APPENDIX B

Summary of DRA Analysis of Late-Filed ALJ Exhibits

A. Estimation of hydrotest costs used to calculate disallowances for pipe replacement projects

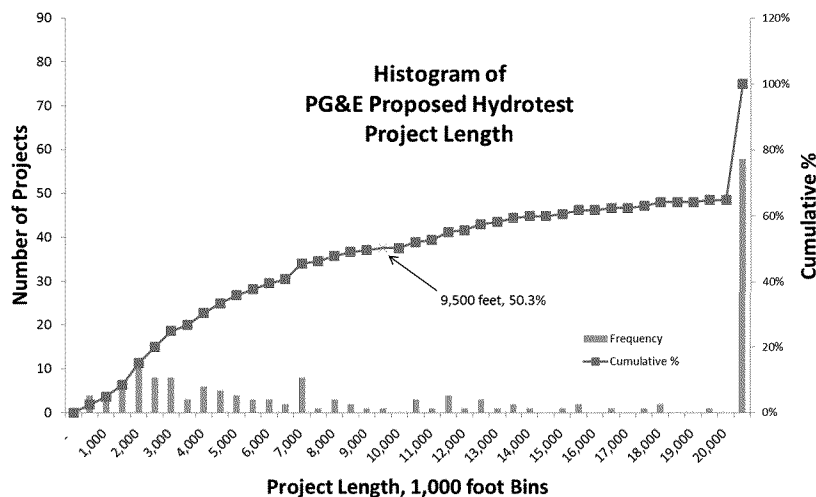
In addition, the record shows that hydrotest costs per foot decrease with increased length of a project, as fixed costs are spread over a larger length of pipe. The following chart shows hydrotest costs per foot for PG&E's 165 proposed hydrotests projects, as a function of the length of each project:

This chart shows that short test projects, including all those shorter than 10,000 feet, have a cost per foot higher than \$95.8.

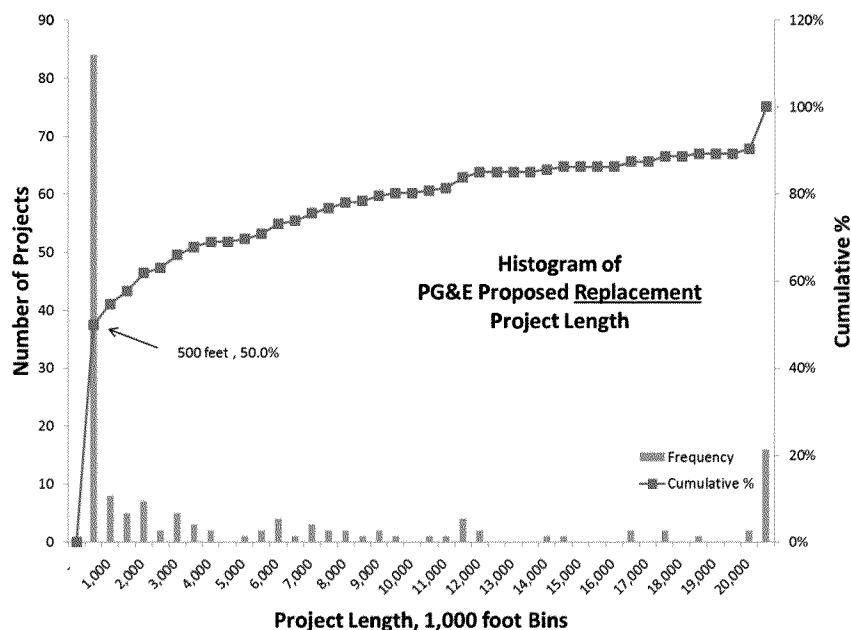
histogram of the 165 hydrotests shows the number of tests (y axis) within each project length bin (x axis):¹¹

This chart shows that approximately 2/3 of the *hydrotest* projects are longer than a mile, and 58 projects are longer than 20,000 ft. These long projects, which have a low cost per foot as shown above, drive the average cost per foot used in the PD.

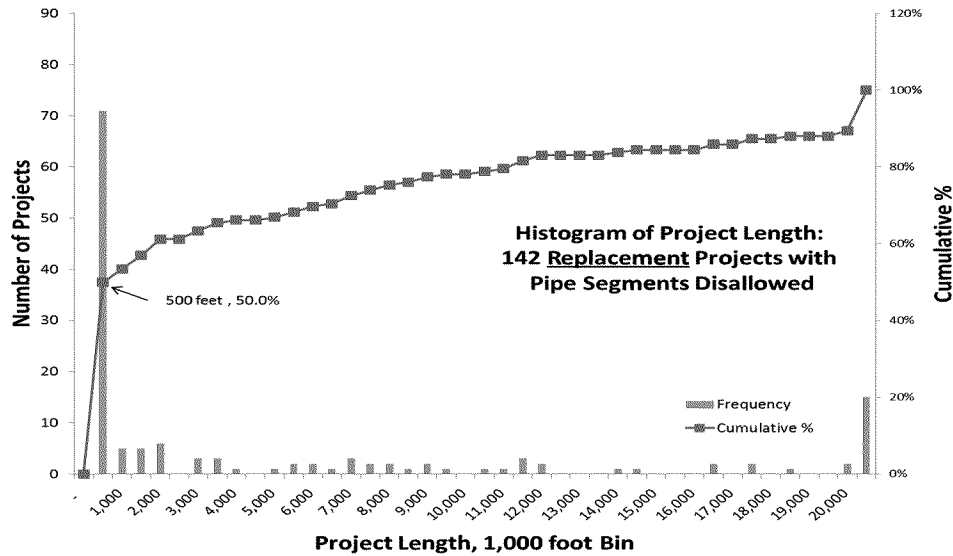
In comparison, the median length of PG&E’s proposed *replacement* projects is 509 feet, over 17 times less than the median length of *hydrotest* projects:¹²

This chart shows that the majority of proposed *replacement* tests (84 of 168) are less than 1,000 feet long.

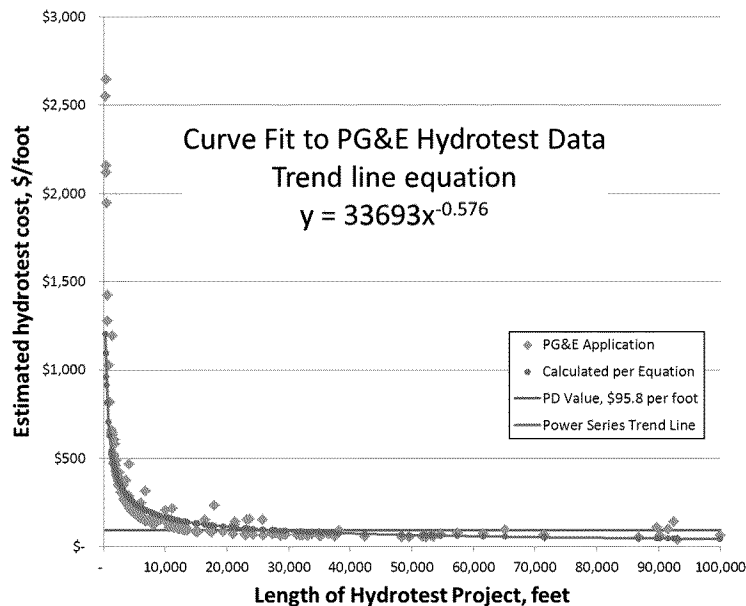
Not all replacement projects have segments that are disallowed, regardless of whether PG&E or DRA’s cost allocation criteria are used. DRA therefore performed a similar analysis on the 142 replacement projects with disallowances using the criteria of Scenario 3 as described in Section II.A.2(a) of DRA’s Comments on the PD.¹³ The median value of these projects, 512 feet, and the frequency distribution are similar to the full set of replacement projects:¹⁴

This data shows that PG&E pipe *replacement* projects are much shorter than *hydrotest* projects, and that the single estimated hydrotest cost of \$95.8 per foot is inappropriately low for use for replacement projects, the majority of which have short pipe lengths.
